CPED STAFF REPORT

CPC Agenda Item #4
 September 15, 2014
 BZZ-6732

Property Location: 2301 Central Avenue Northeast and 949 23rd Avenue Northeast
Project Name: Neighborhood Health Source Clinic and Corporate Offices
Prepared By: [Lisa Steiner](#), City Planner, (612) 673-3950
Applicant: Landform
Project Contact: Darren Lazan
Request: To allow a new approximately 13,756 square foot clinic building.
Required Applications:

SITE PLAN

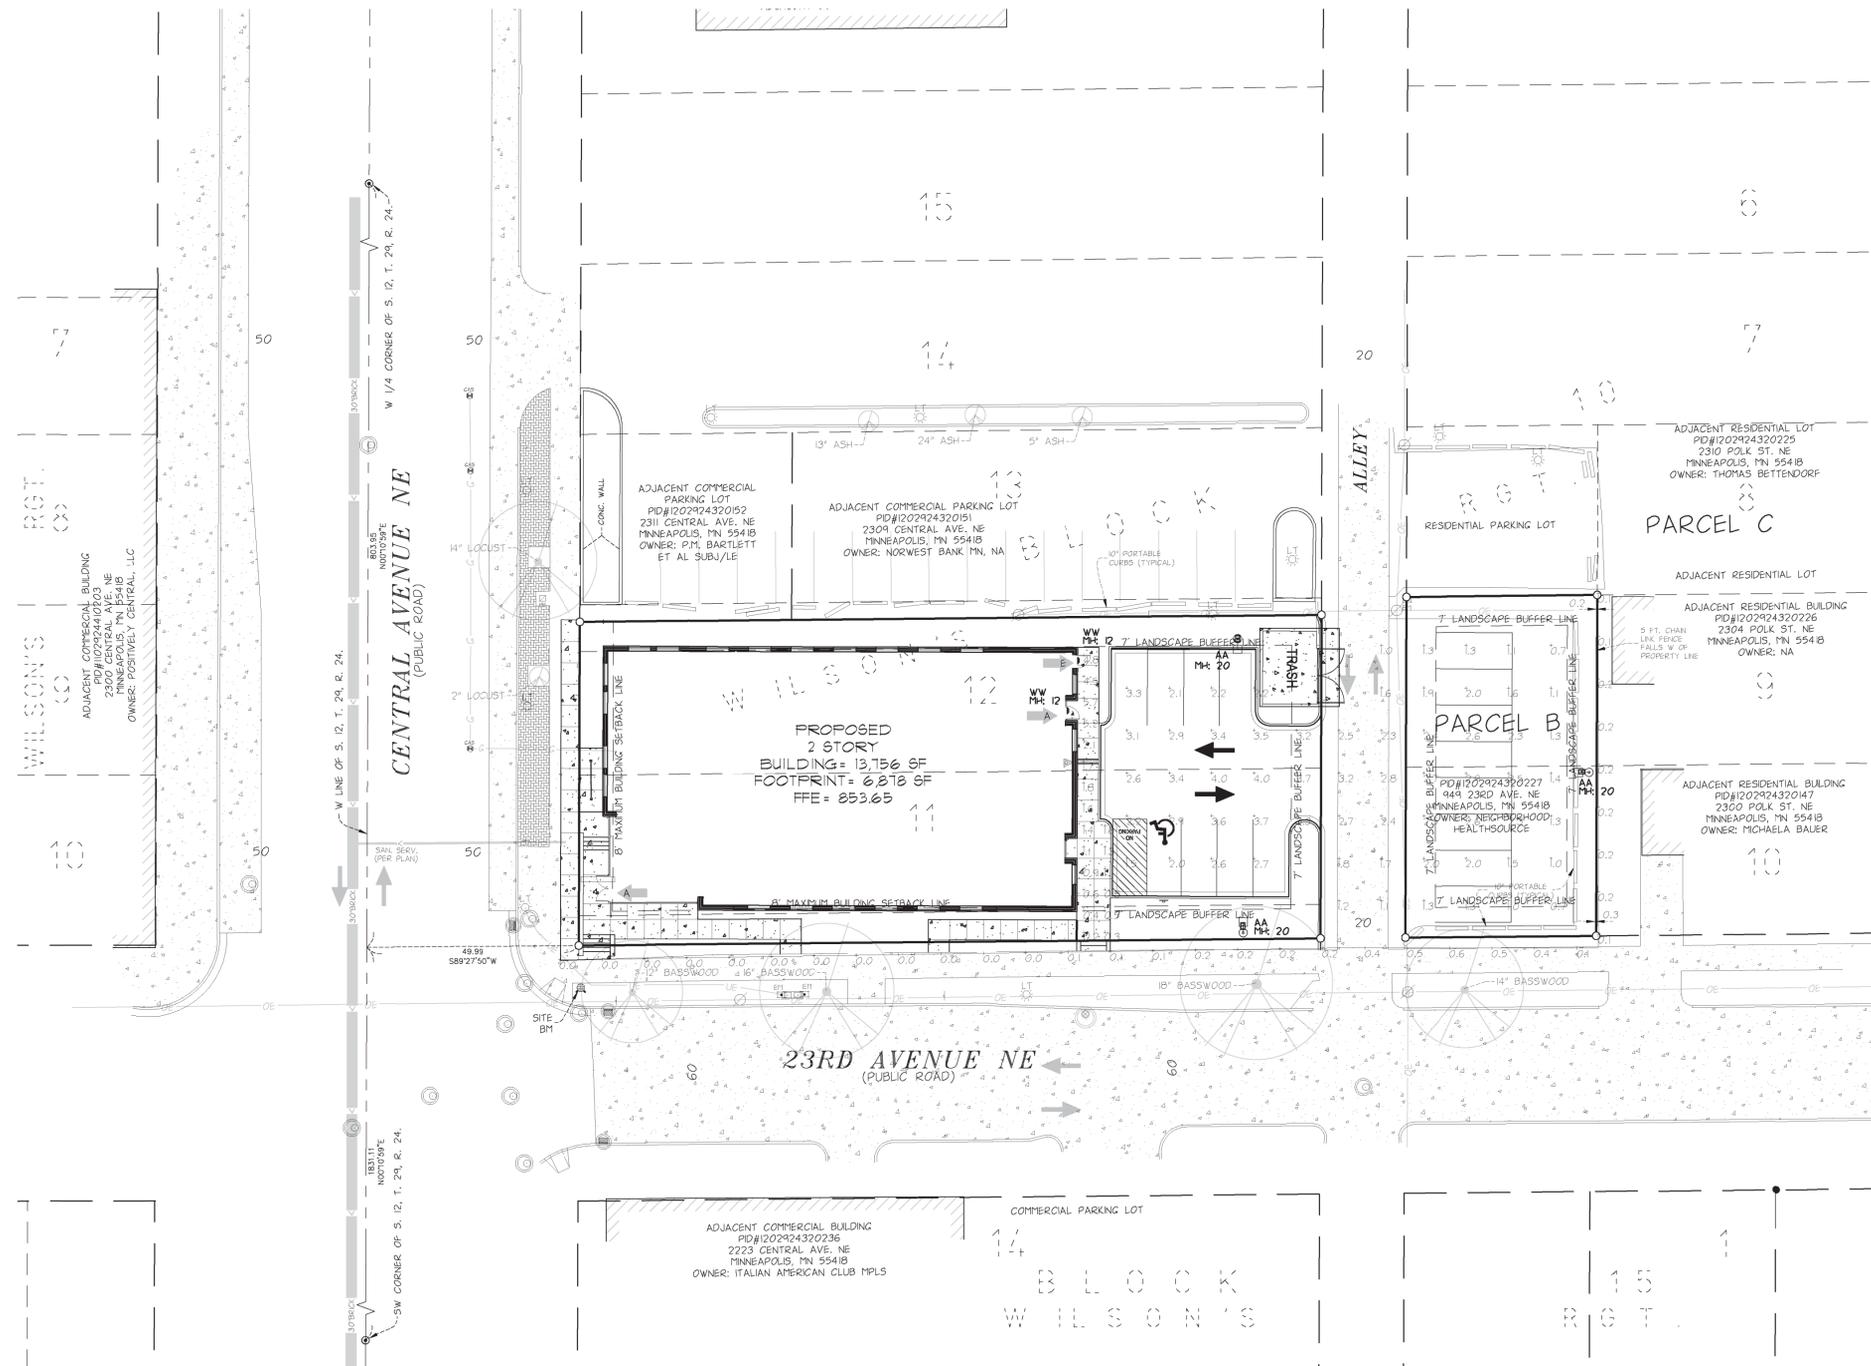
- For the most part, the building reinforces the street wall, maximizes natural surveillance and visibility, and facilitates pedestrian access and circulation. However, staff is recommending as a condition of approval that no portion of the building be further than 8 feet from the property line in order to reinforce the street wall along 23rd Avenue as required by the PO District standards and plan guidance.
- The proposed building will be located approximately 7 feet from the front property line along Central Avenue NE and 9 feet 8 inches from the corner side lot line along 23rd Avenue. For the

- Plans submitted show a trash enclosure at the northeast corner of the 2301 Central Avenue NE parcel but do not provide specific details about the material or height of the proposed enclosure. Staff is recommending as a condition of approval that the trash containers be enclosed on all four sides with screening compatible with the principal structure not less than two feet higher than the refuse container.

1. Approval of the final site, elevation, floor, landscaping, and lighting plans by CPED.
2. All site improvements shall be completed by September 15, 2016, unless extended by the zoning administrator, or the permit may be revoked for non-compliance.
3. No portion of the building walls along Central Avenue NE or 23rd Avenue NE shall be further than 8 feet from the property line.

EAST ELEVATION

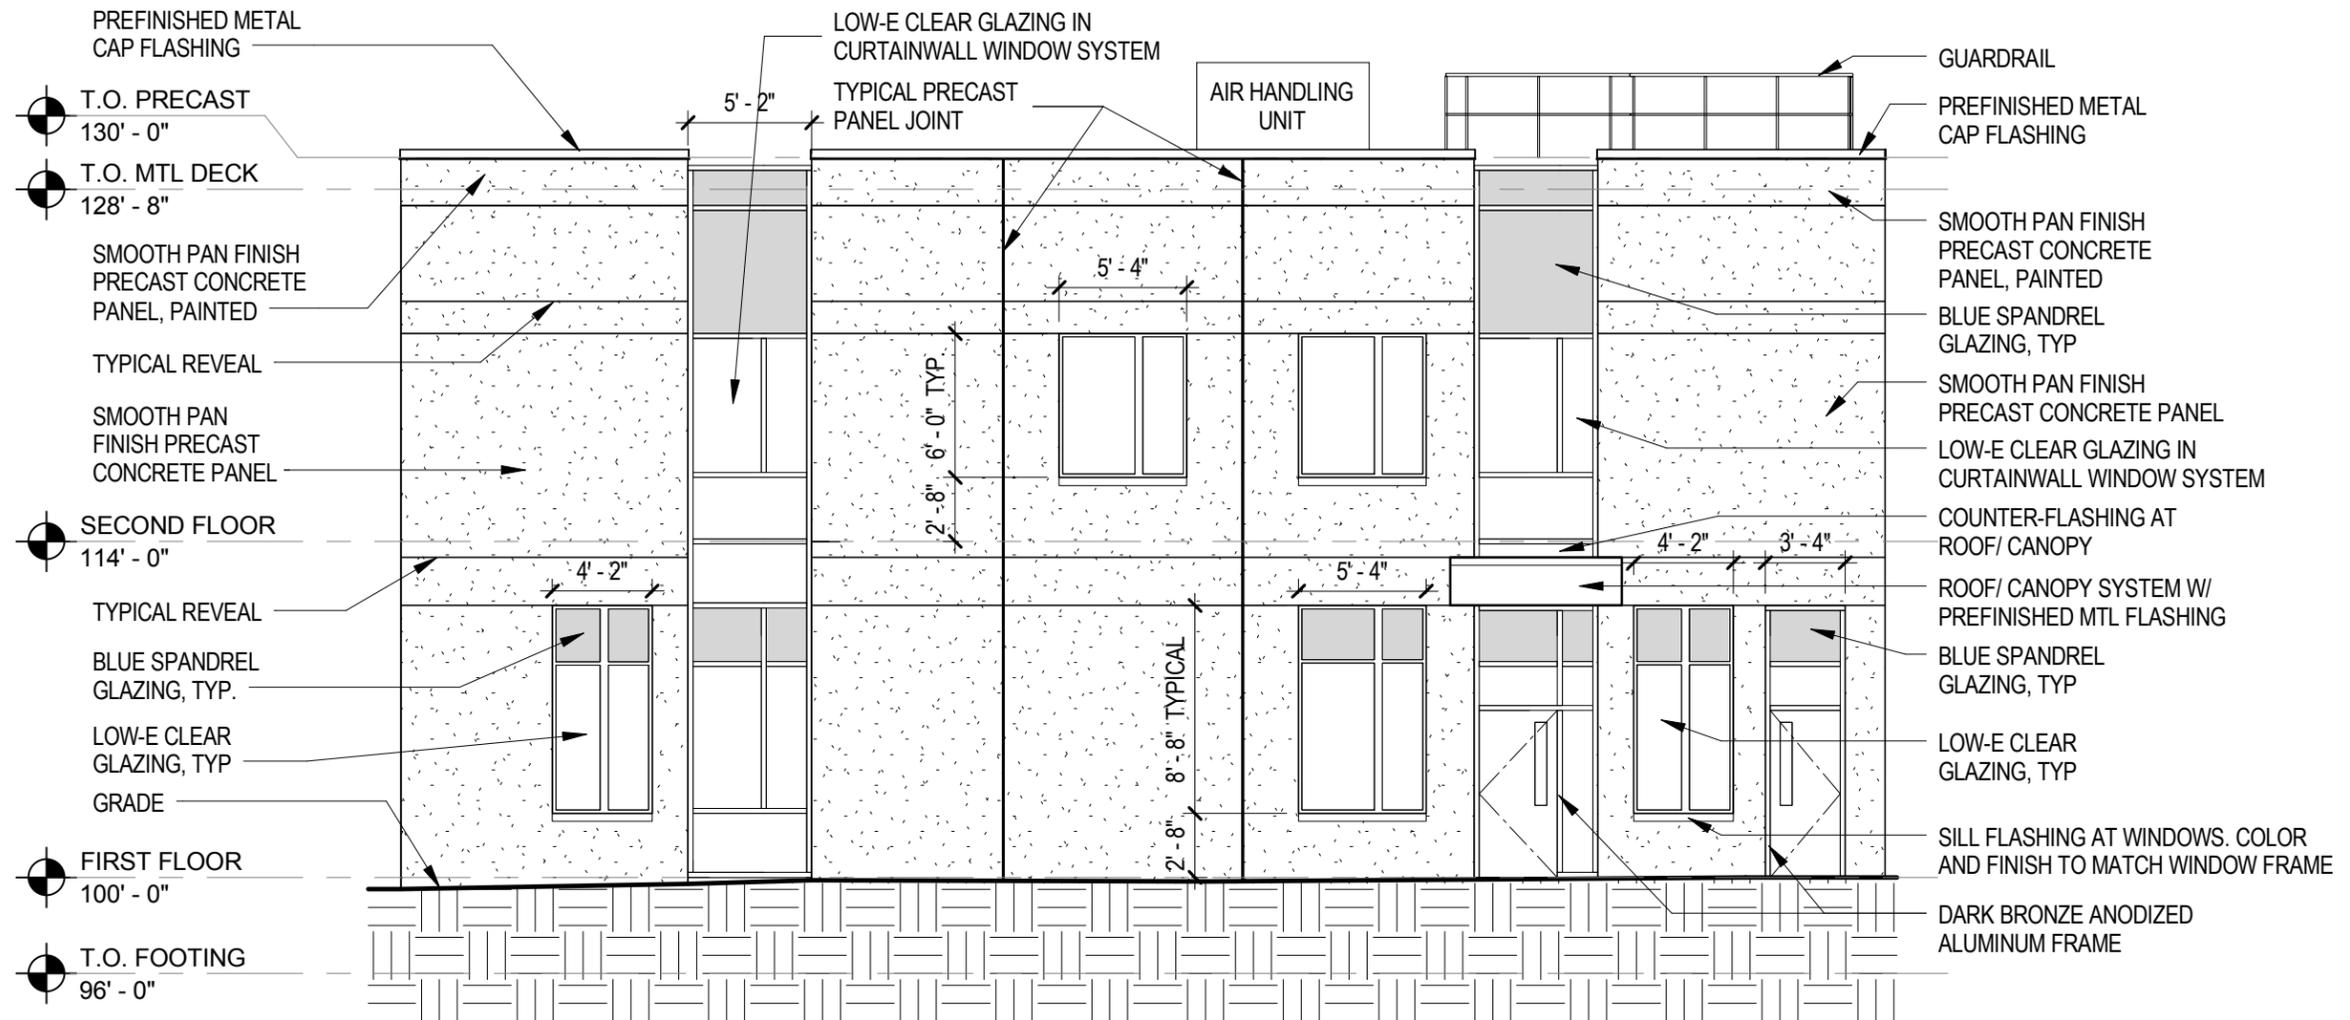
- However, on the east elevation, no brick is incorporated into the design. Alternative compliance is required for this standard. Staff is not recommending that the Planning Commission grant alternative compliance for this item, and is recommending as a condition of approval that at least 10% of the east elevation incorporate brick, in order for the rear elevation to be similar to and compatible with the front of the building.

- **Rear and side wall compatibility of materials and appearance.** The exterior materials and appearance of rear and side walls are required to be similar to and compatible with the front of the building. The exterior materials and appearance of the east elevation is not compatible with the front elevation of the building. The front of the building facing Central Avenue is 31% thin set brick and 11% precast concrete panels. On the east elevation facing the on-site parking lot, no brick is incorporated into the design at all. Staff is not recommending that the Planning Commission grant alternative compliance for this item, and is recommending that the Planning Commission require at least 10% of the east elevation to incorporate brick so that the rear elevation is similar to and compatible with the front of the building.

- **Window requirement facing on-site parking lot.** Thirty percent of walls on the first floor facing an on-site parking lot are required to be windows. The proposal incorporates 127 square feet of windows on the first floor of the east elevation facing the on-site parking lot, which amounts to approximately 26% of the building wall. However, staff finds that because the site plan includes significantly more windows than the required 10% on the second floor of the building, windows on the north elevation where no windows would be required by site plan review standards, and additional landscaping on the site, that the adverse effects of the alternative would be mitigated. Therefore, staff is recommending that the Planning Commission grant alternative compliance for this standard.

4. At least 10% of the east elevation shall incorporate brick.
5. Trash containers shall be enclosed on all four sides with screening compatible with the principal structure not less than two feet higher than the refuse container.
6. All mechanical equipment shall be screened per section 535.70 of the zoning code.
7. All signs shall comply with Chapter 541 of the zoning code. All new signage requires a separate permit from CPED.
